**SUBJECT: NMED/AIP Reports on Sandia National Laboratory's
Chemical and Mixed Waste Landfills**

NMED/DOE/AIP-94/3

**Review of Ground-Water Monitoring at Sandia National
Laboratories' Mixed Waste Landfill**

Figure 1. Map of Mixed Waste Landfill showing monitor wells, trenches, and waste pits (modified from Anonymous, 1991).

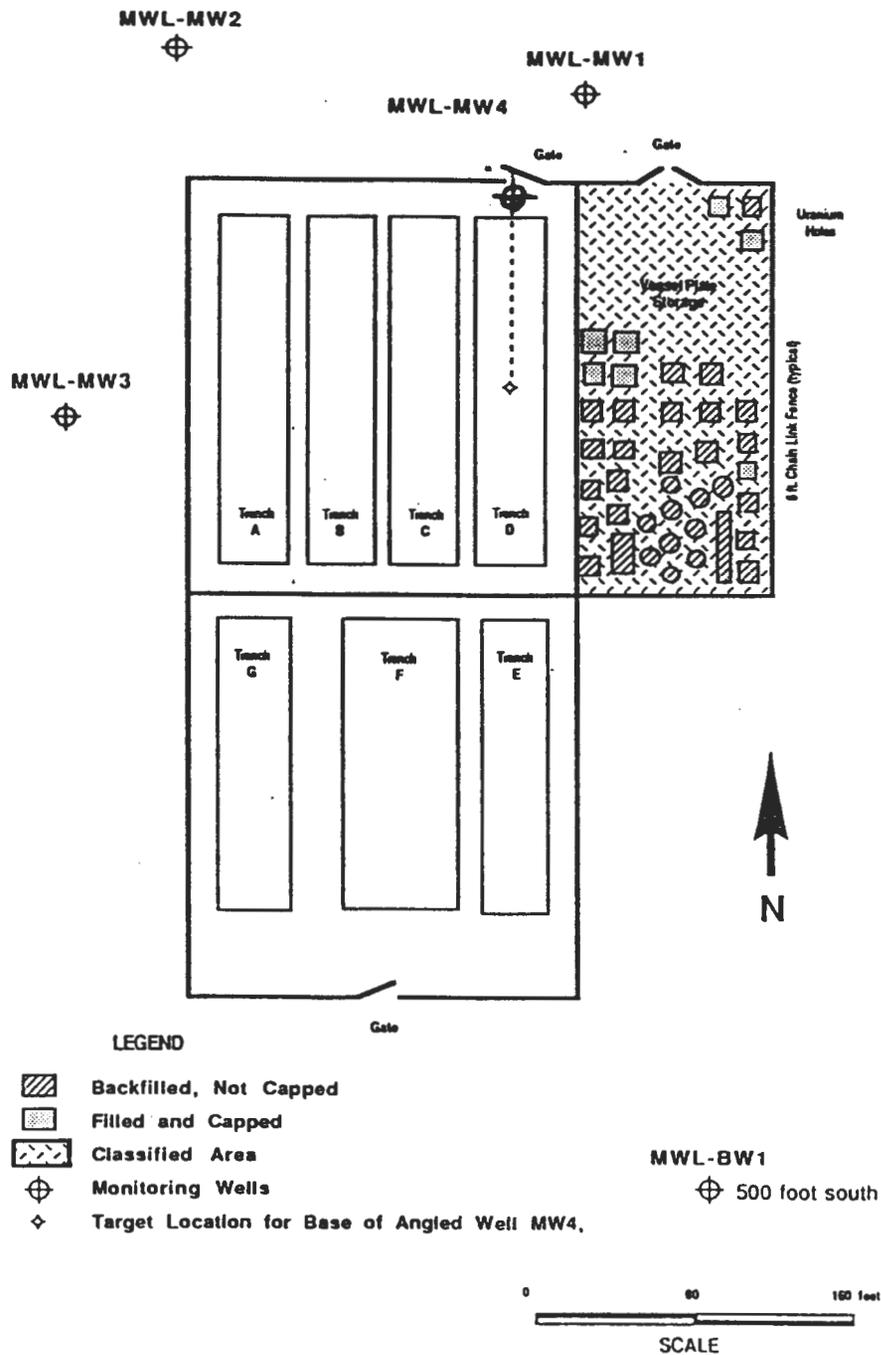
The MWL consists of two adjoining, but discrete areas: the classified waste area located on the northeast corner of the facility, and the unclassified area, comprising the rest of the landfill (Figure 1). Classified wastes were buried in small pits which were typically capped with concrete pads. Unclassified wastes were disposed in seven trenches, each estimated to be roughly 32 feet wide by 140 ft long by 25 ft deep (Anonymous, 1991).

A total of five ground-water monitor wells have been installed at the MWL (Figure 1). A fairly detailed report describing the installations of monitor wells MWL-MW2, MWL-MW3, and MWL-BW1 was prepared for SNLA by Ecology and Environment, Incorporated (Anonymous, 1989). This same report also describes the installation of MWL-MW1, which was drilled similarly and at about the same time period as the 1988 CWL monitor wells. The first well, MWL-MW1, was installed at the MWL in 1988 by air-rotary casing-driven drilling methods. Monitor wells MWL-MW2, MWL-MW3, and MWL-BW1 were completed by September 1989 using mud-rotary drilling (Anonymous, 1989). In general, installation of the latter three wells consisted of drilling exploratory pilot holes for soil sampling and geophysical logging, followed by reaming of the pilot holes to facilitate construction of the wells.
